LEARNING RESOURCES CENTER
BUILDING 'D' AND 'CR' REMODEL

VENTURA COLLEGE

September 24, 2001
KBZ Job No. 93-18

INSPECTOR COPY

10 SIGN DETAILS
SCALE: 1/4" = 1'-0"

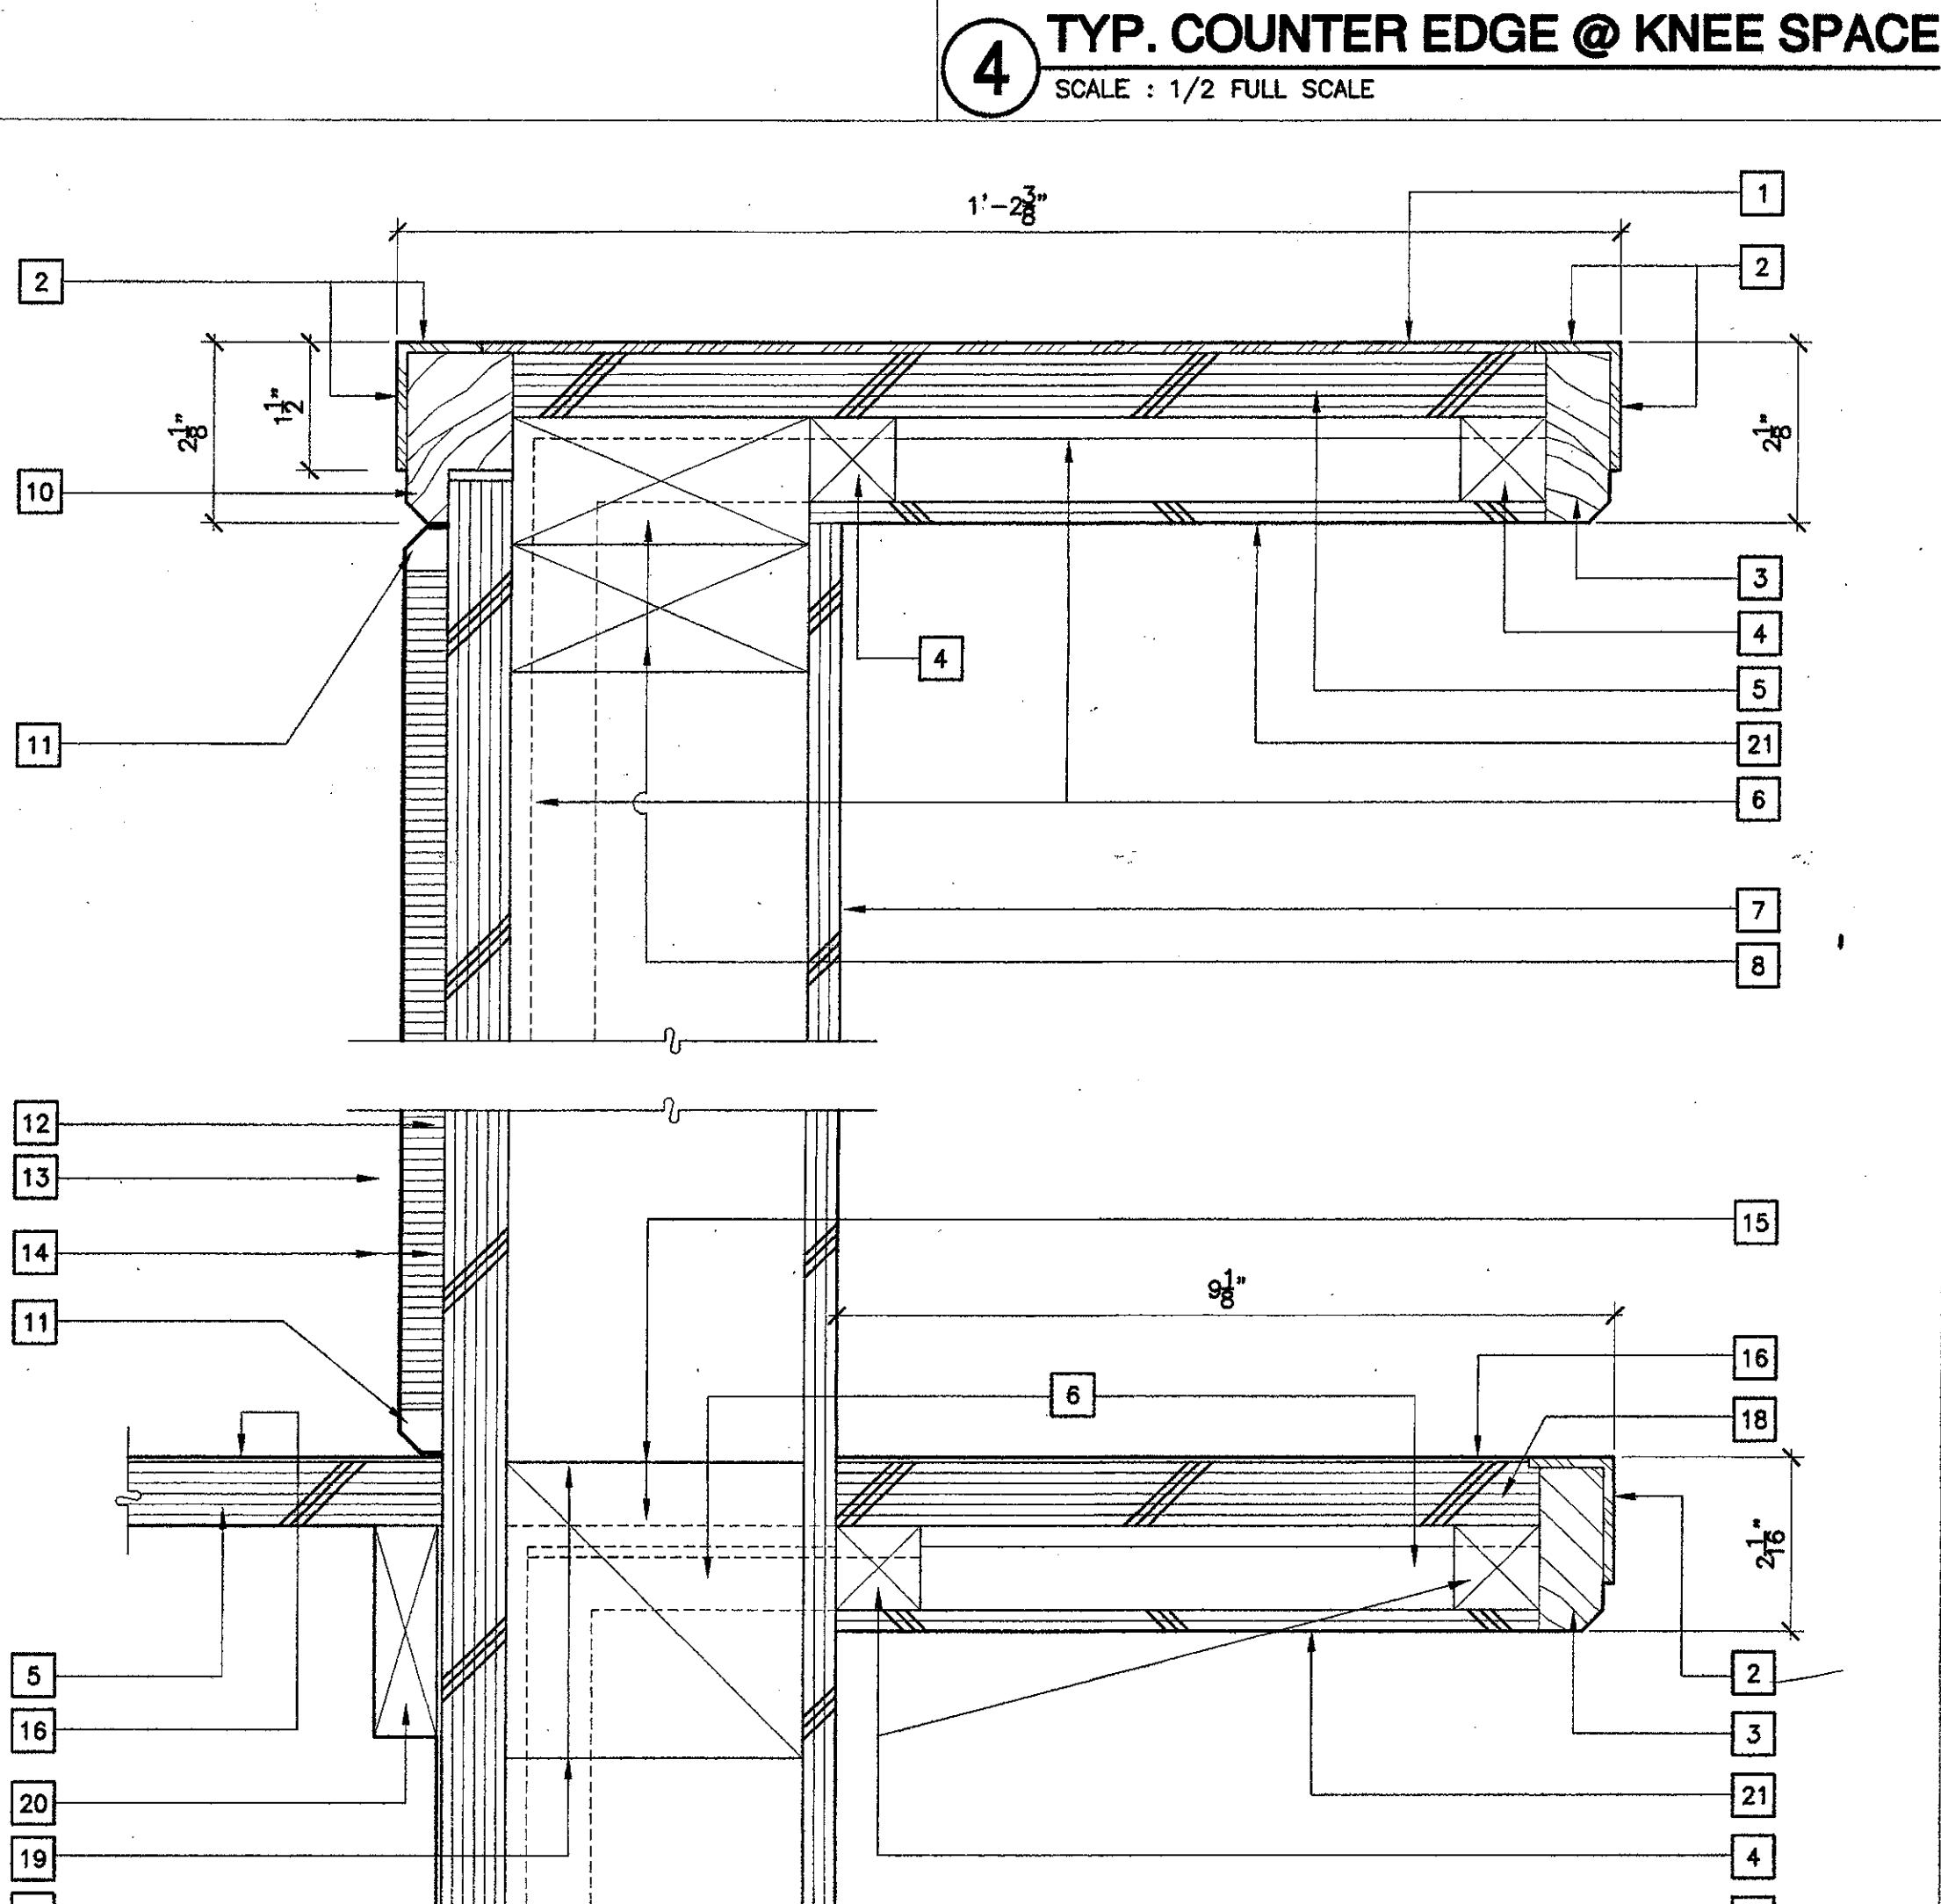
ITEM 33. Drawing Sheet A-543. *ADDENDUM 2*
Detail 9B describes a typical room identification panel sign as called for by
Keynote 17 on Door Schedules - Sheet A-611. The panel signs shall be 4" high
with 1" high raised letters and numbers and a minimum of 1 1/2" from edge of first
and last characters to edge of sign.

ITEM 39. Additional information for sign shown on detail 9B/A-543
Overall sign dimension is: 4" wide x 2" high with 5/8" high raised letters and
numbers

COLUMN SECTION

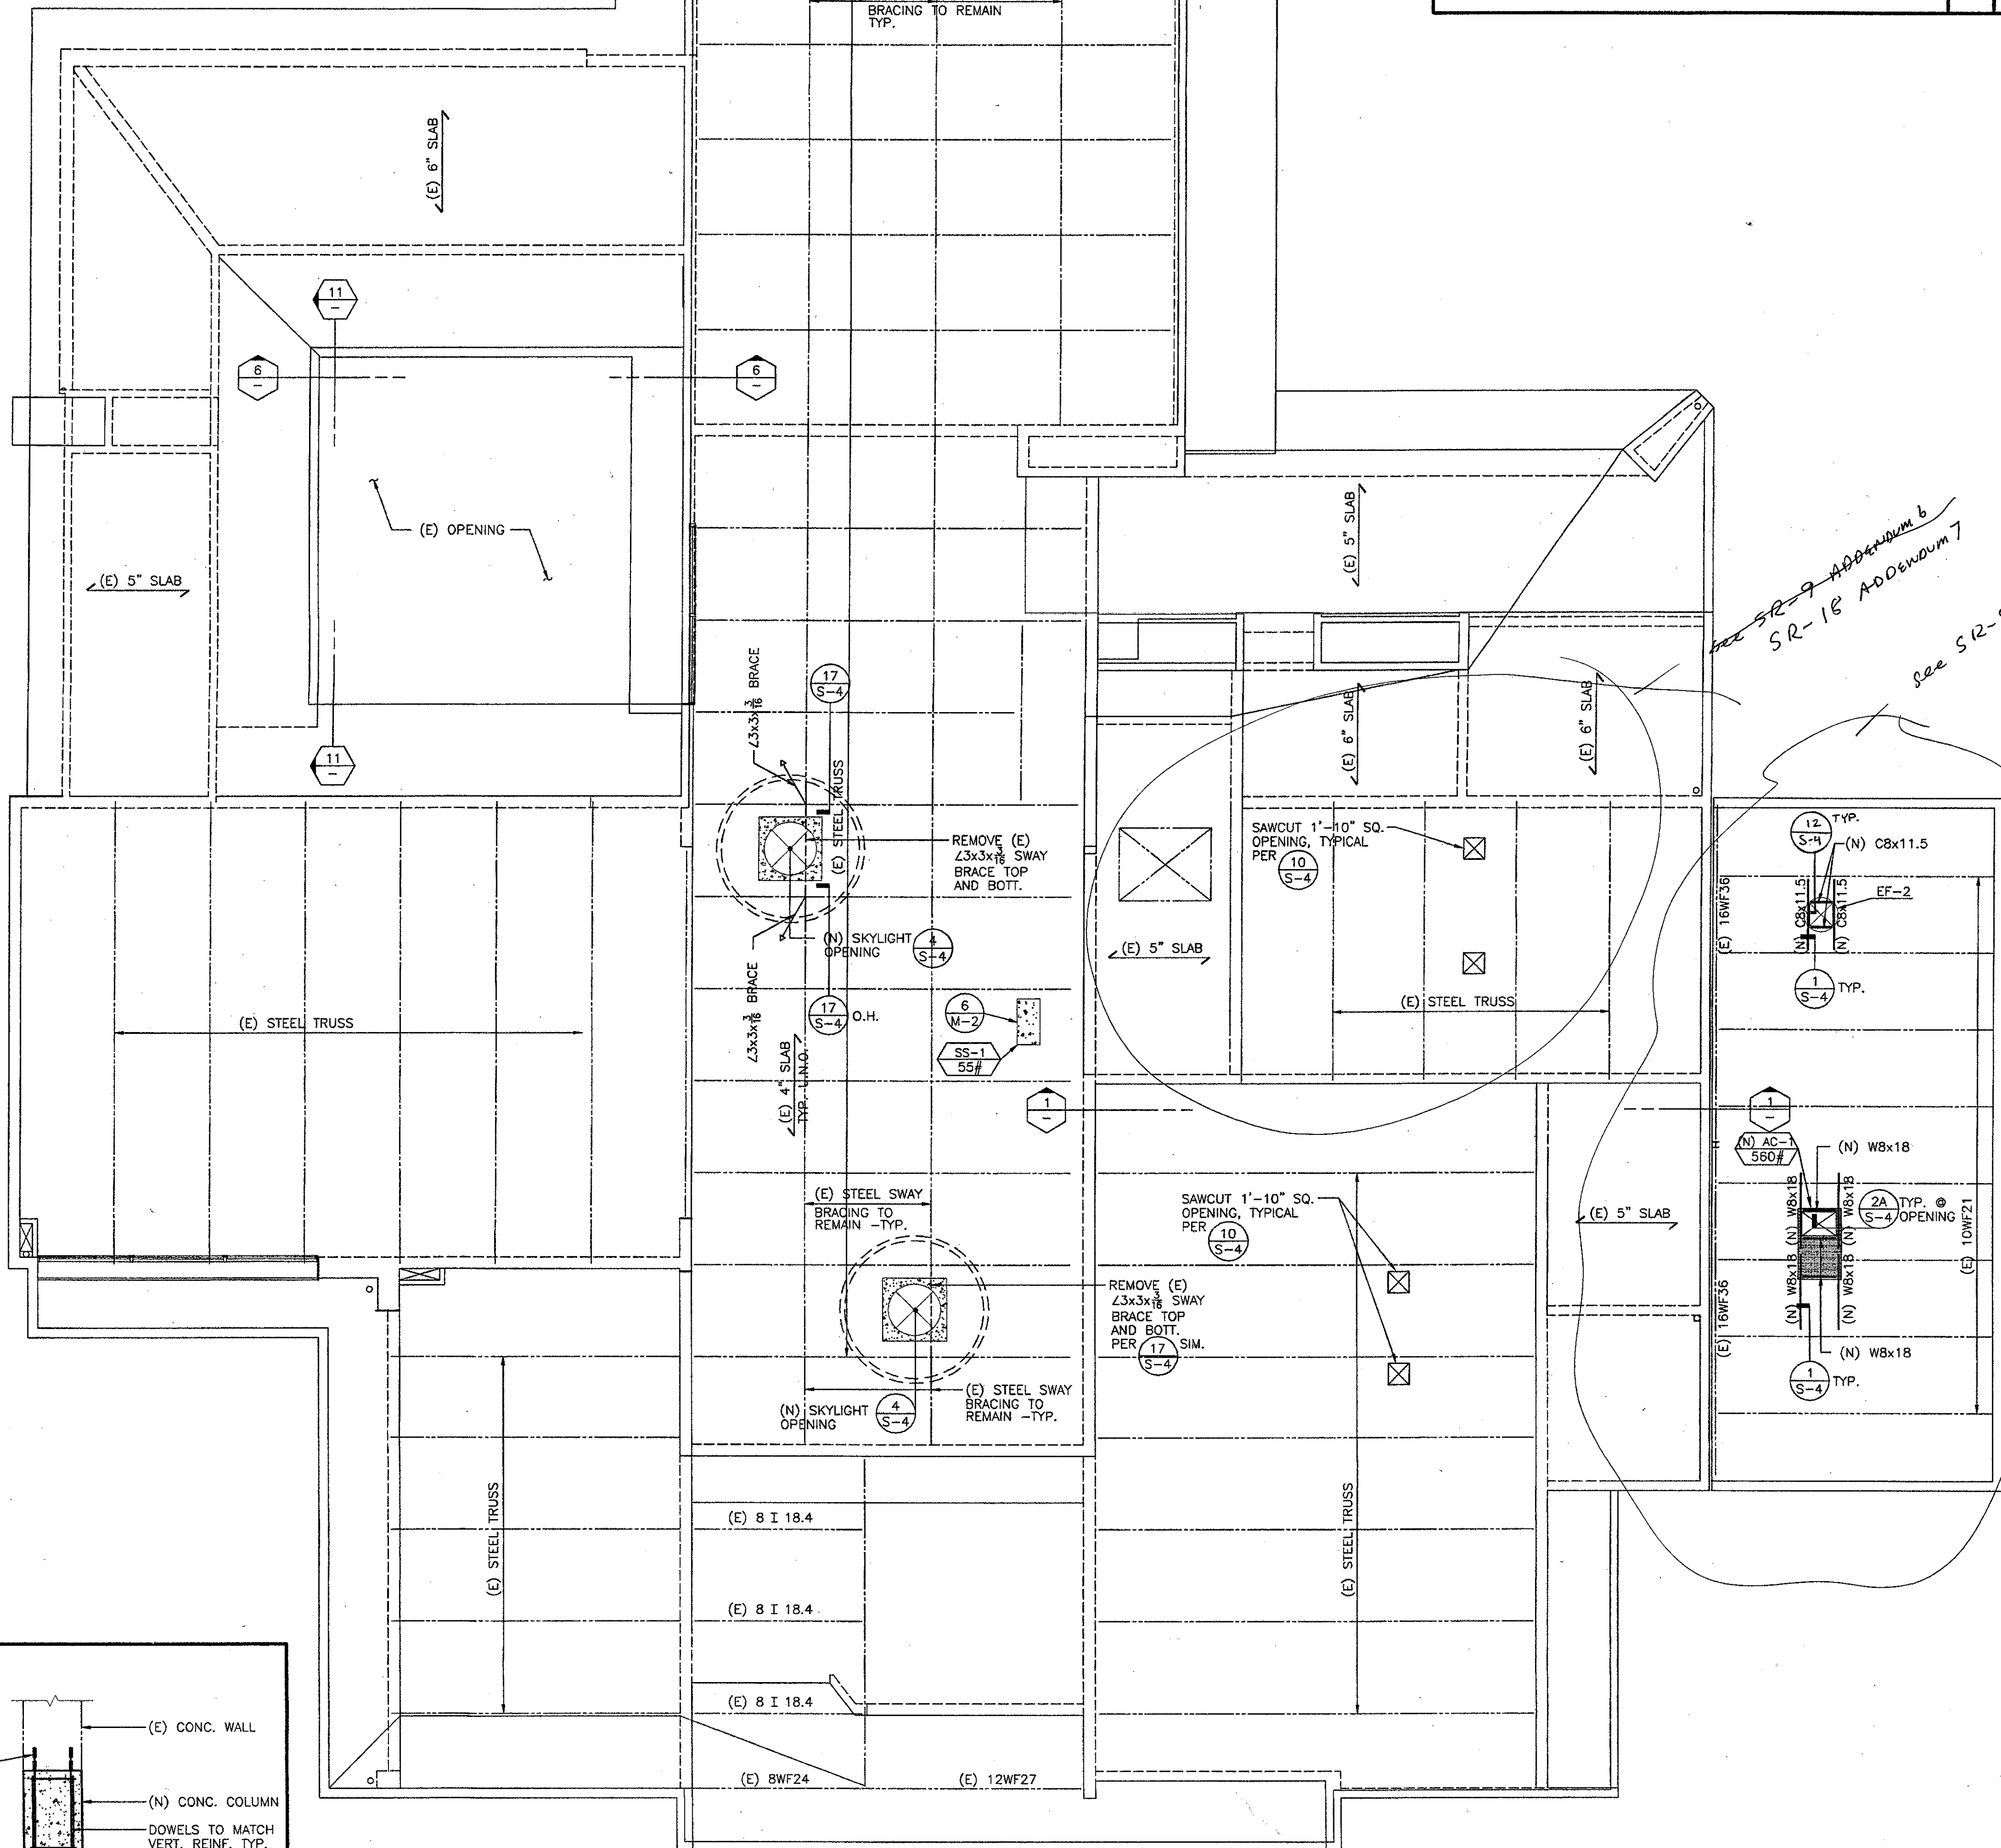
Drawing Sheet S-3, Appendix 2. At Details 17 and 21 omit all references to detail 22 on Sheet S-3.

MECHANICAL PLAN, CONTROL POINTS & EQUIPMENT SCHEDULE BUILDING 'D'

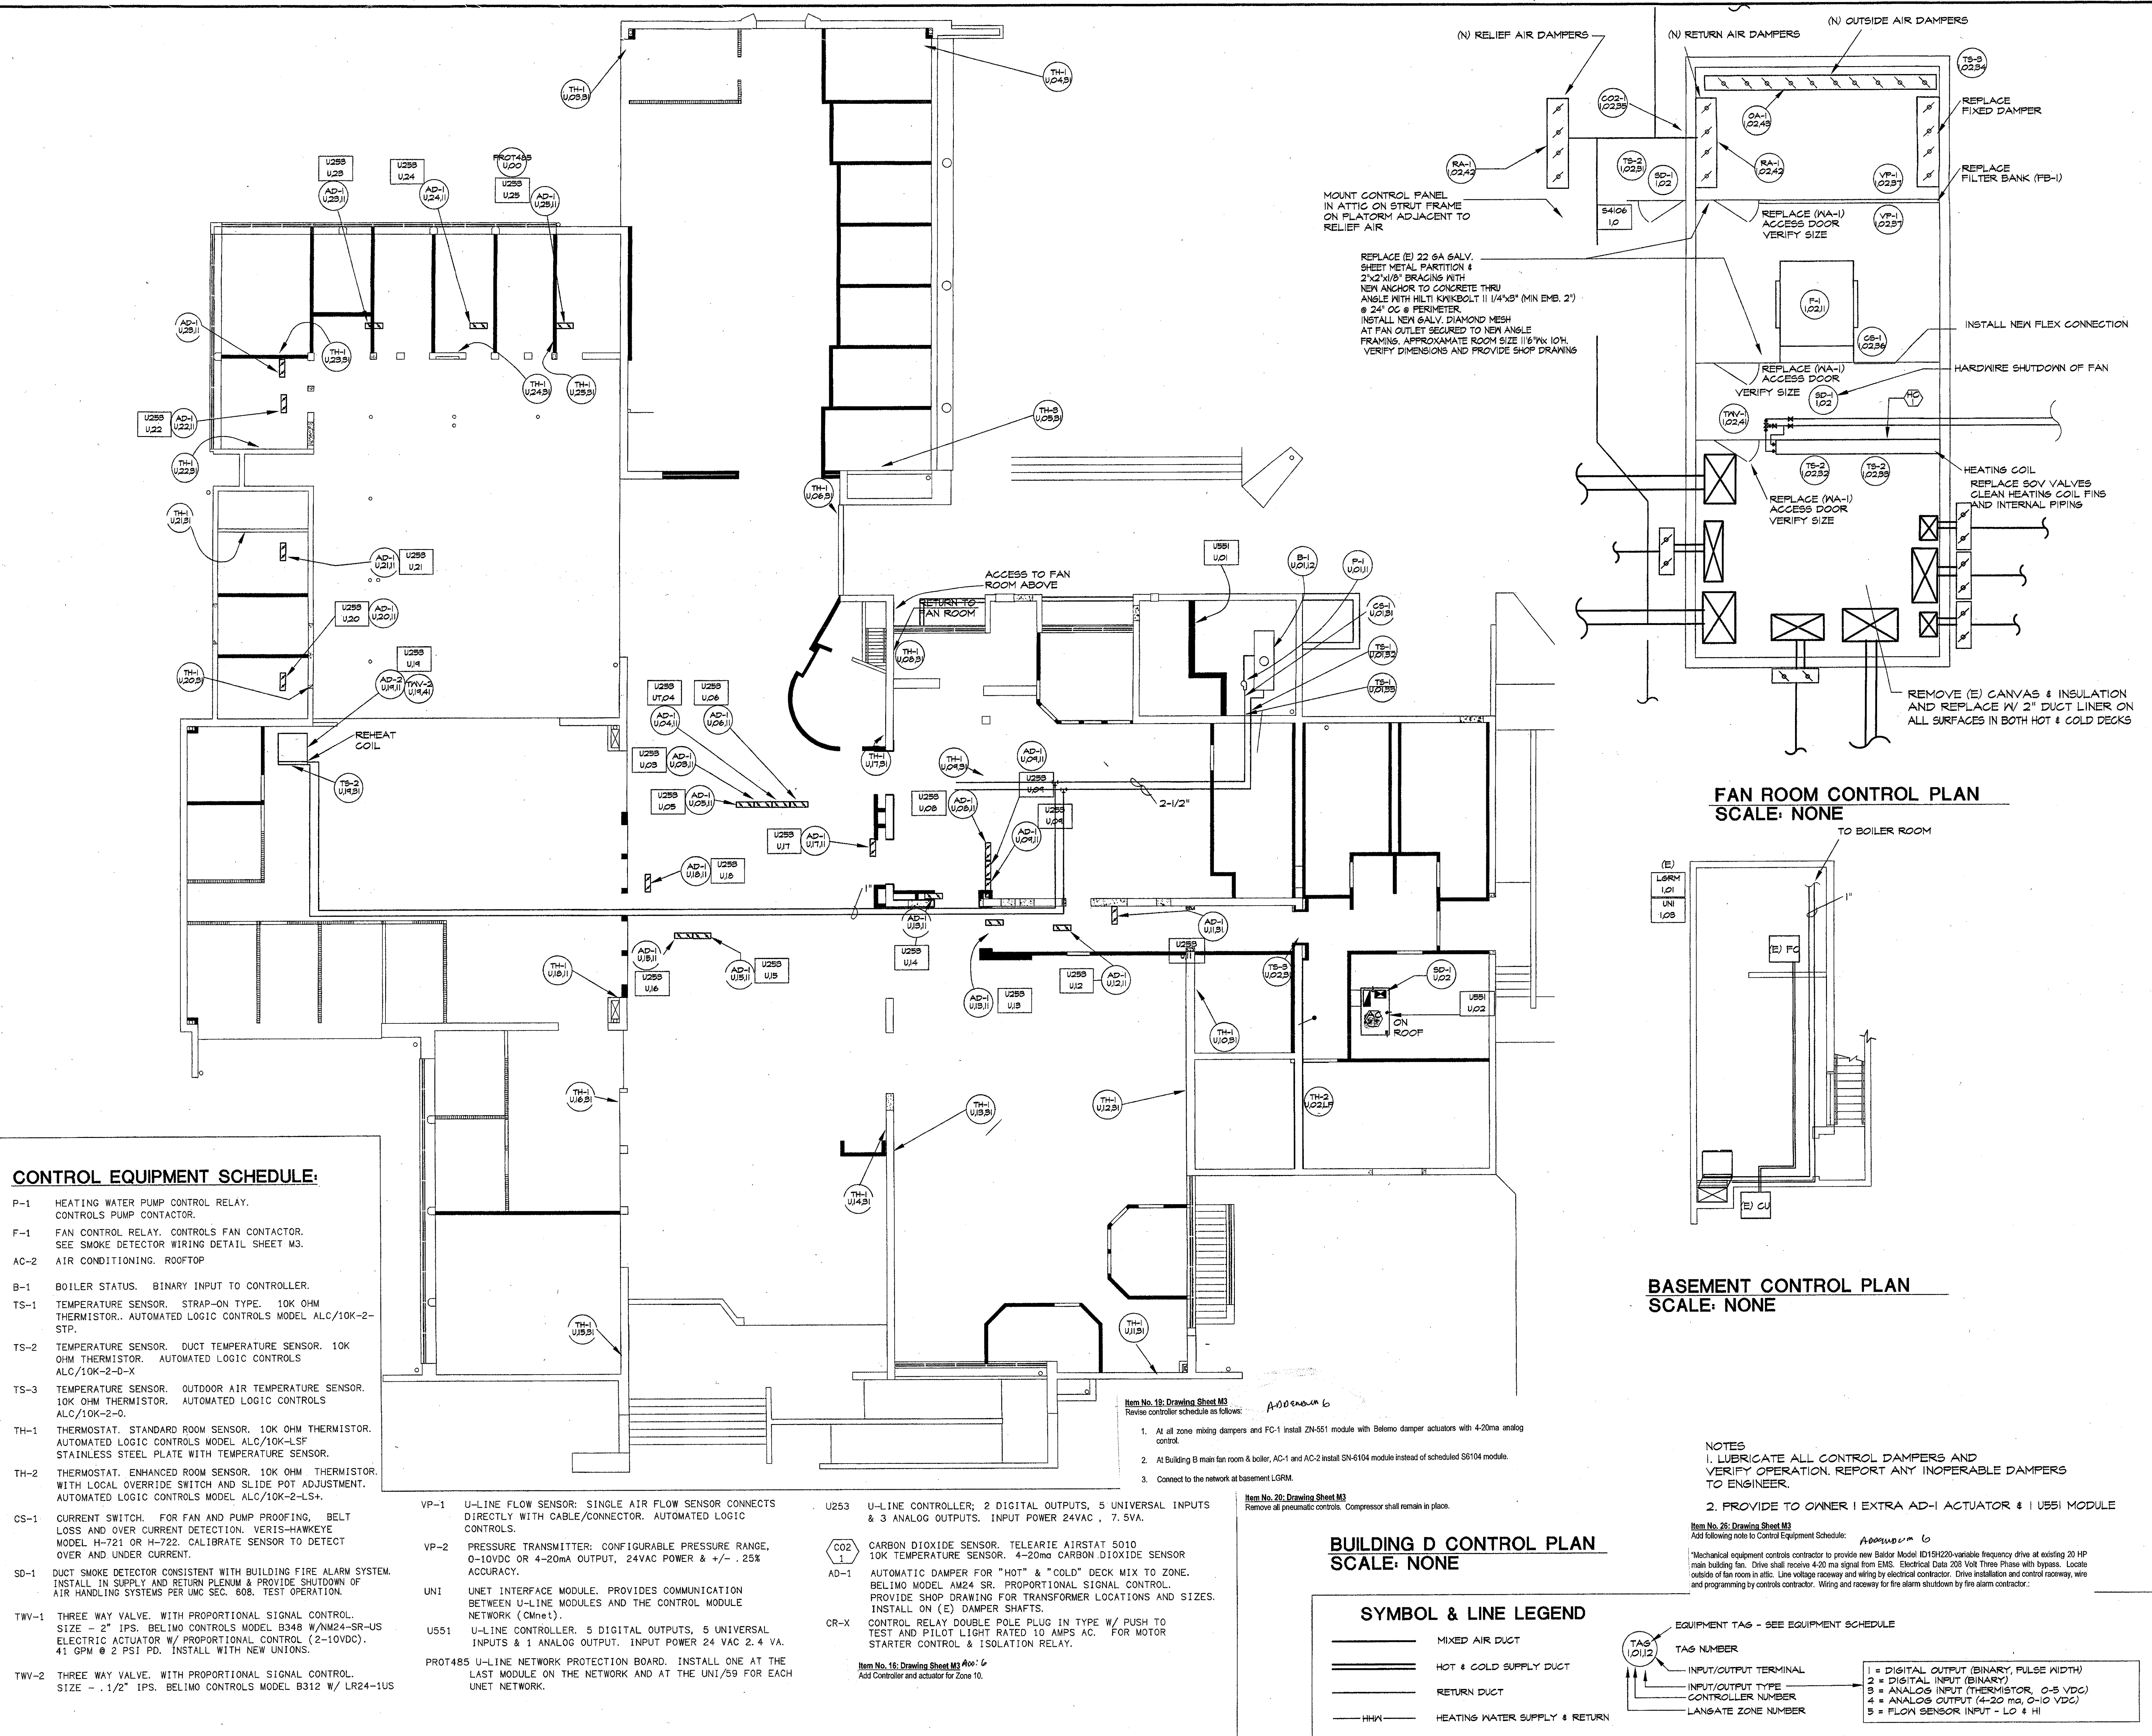
Item No. 19: Drawing Sheet M3
Revise controller schedule as follows:

Item No. 20: Drawing Sheet M3
Remove all pneumatic controls. Compressor shall remain in place.

Item No. 28: Drawing Sheet M3
Add following note to Control Equipment Schedule: *addendum 6*
